ADDENDUM #1

DATE: September 19, 2022

PROJECT: Abbott House Reroofing Project at Maine Maritime Academy, Castine, Maine, BGS Project 3449

ABBOTT HOUSE CASTINE, MAINE	
INDEPENDENT ROOF SERVICES POWNAI, MAINE	SCALE: 1/16" = 1'
DATE: 09-02-22	FILE NAME: MMA
TITLE: PROPOSED ROOF PLAN	
DATE: 09-02-22	DRAWING#: R2

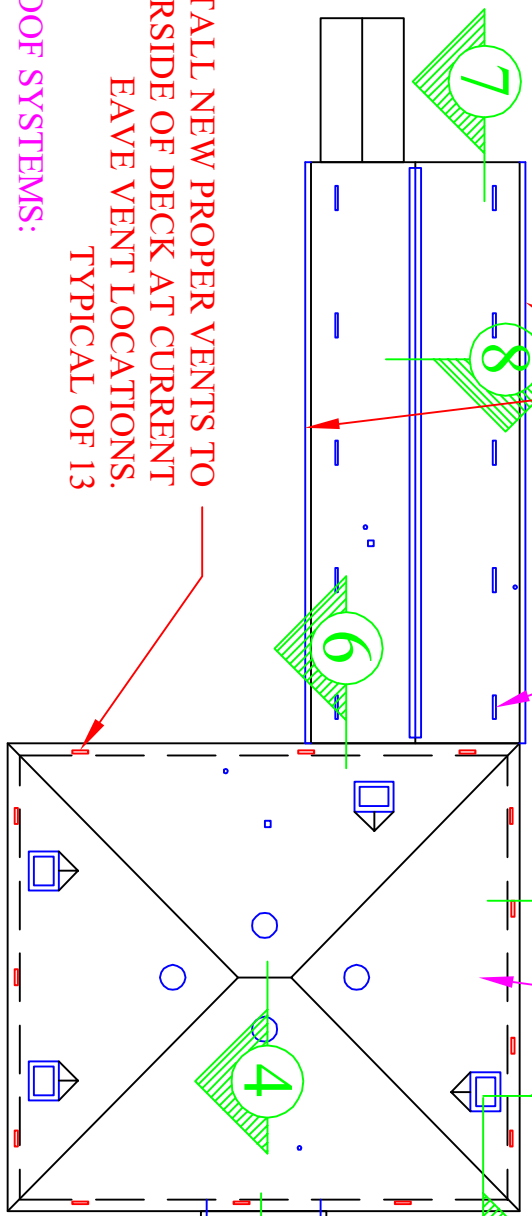
DESCRIPTION	<u>Relating to Project Manual</u> 1. Independent Roof Services drawings Revise drawings R2, R4, R8, and R11 as shown on attached revised drawings. <u>Relating to Drawings</u> 1. Drawings S1 and S2 Revise drawings S1 and S2 as shown on attached revised drawings.
ATTACHMENTS	IRS drawings R2, R4, R8, and R11 and Lincoln/Haney Engineering drawings S1 and S2.

AIRHAWK B-144 ATTIC VENT
TYPICAL OF 8

SHADOWHAWK LPG72BL
TYPICAL OF 10

NEW 0.032" WHITE ALUMINUM
5" K-STYLE GUTTER

INSTALL NEW 2x3
ALUMINUM
DOWNSPOUTS TO
EXISTING DRAINAGE
PIPES AT GRADE.

INSTALL NEW PROPER VENTS TO
UNDERSIDE OF DECK AT CURRENT
EAVE VENT LOCATIONS.
TYPICAL OF 13
